RIVER VALLEY BANK OFFER FOR DEDICATION AND RIGHT OF WAY ABANDONMENT

REQUEST FOR COMMENTS

RE: **Project Description** – River Valley Bank Tentative Parcel Map, Development Review and Sign Permit(s) (17PLN-16) in the Office Professional (OP) Zone located at 580 Idaho Maryland Road. The Tentative Parcel Map proposes division of an approximate ± 1.79 acre parcel into 3 parcels consisting of Parcel 1 – 46,773 sq. ft.; Parcel 2 – 2,997 sq. ft.; and Parcel 3 – 28,164 sq. ft. The Development Review Permit is for the construction of a 3,500 sq. ft. bank and 1,500 sq. ft. retail/office building. A Sign Permit is required for monument and building signage.

File No: 17PLN-16

SITE LIGHTING PLAN

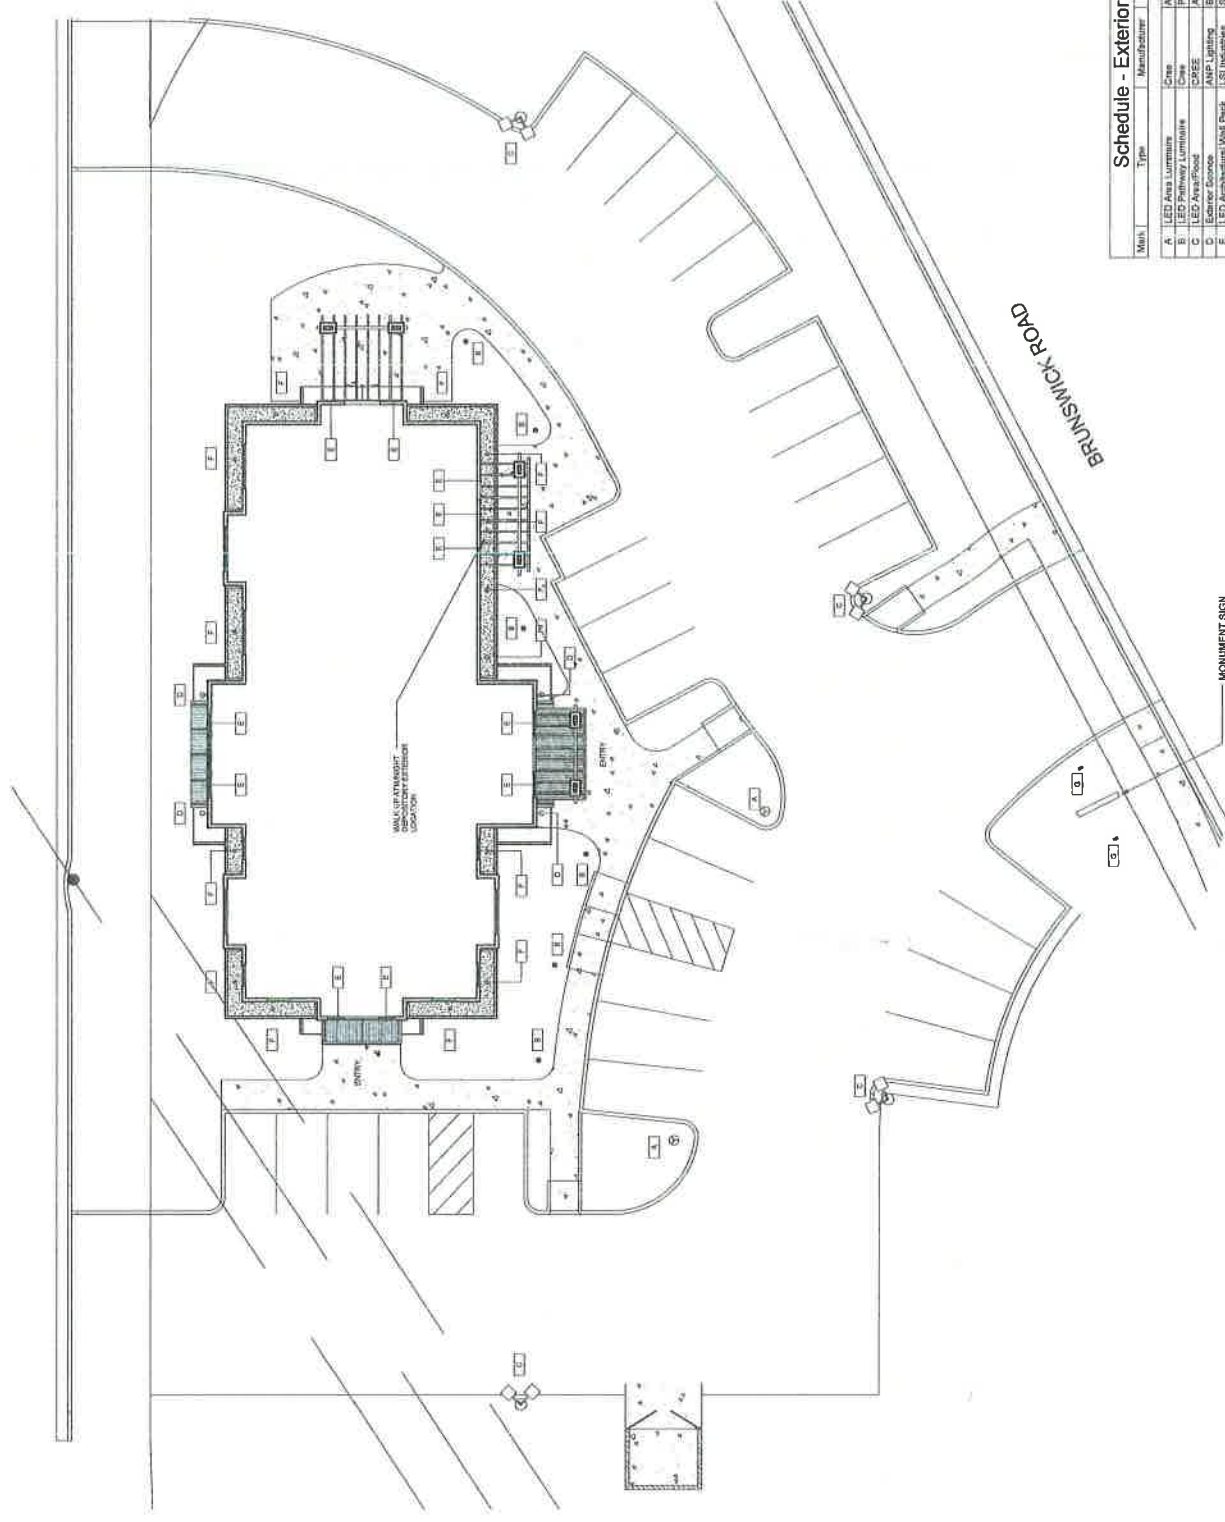
9. Sidewalk: It appears that the site plan includes a concrete path for pedestrians, consistent with Grass Valley General Plan Circulation Element goals, objectives, and policies. Nevada County supports the path as a means to make the project more accessible to pedestrians.

BUILDING SIGNAGE

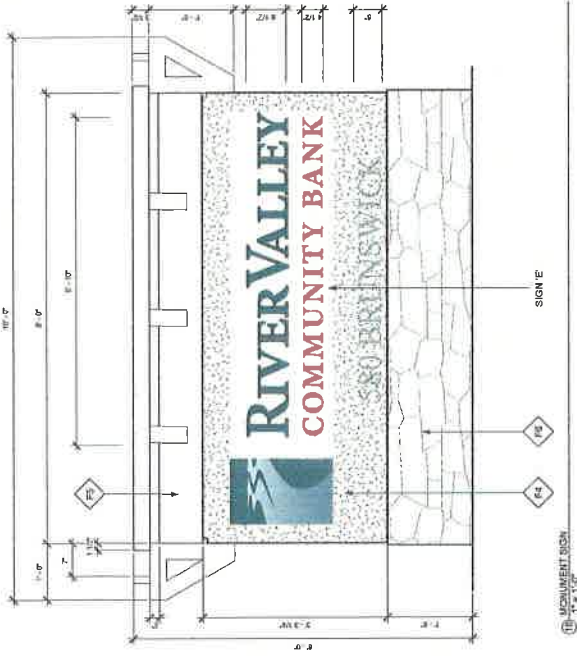
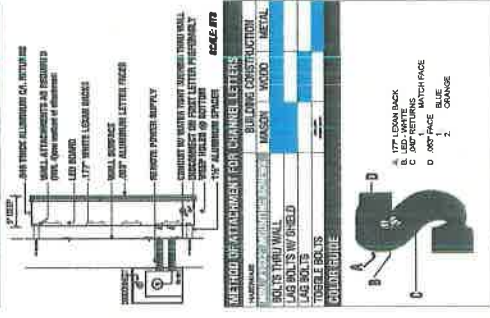
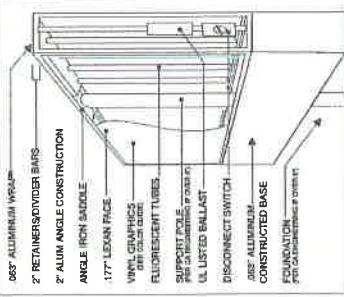
Signage – A new monument and building signage is proposed with the proposed project (Sheet A-08). The proposed 4 foot by 8 foot monument sign is located along Brunswick Road at the proposed entryway location. The monument sign includes a concrete foundation with decorative cap. The monument sign will accommodate the leasable tenant space on Parcel 2 in addition to River Valley Bank. The inset signage is internally illuminated LED of 9 sq. ft. each. The wall signage consists of signs on the west and south elevations of 36 and 28.5 sq. ft. respectively. The signage is individual channel letters sized according to the west and south facades.
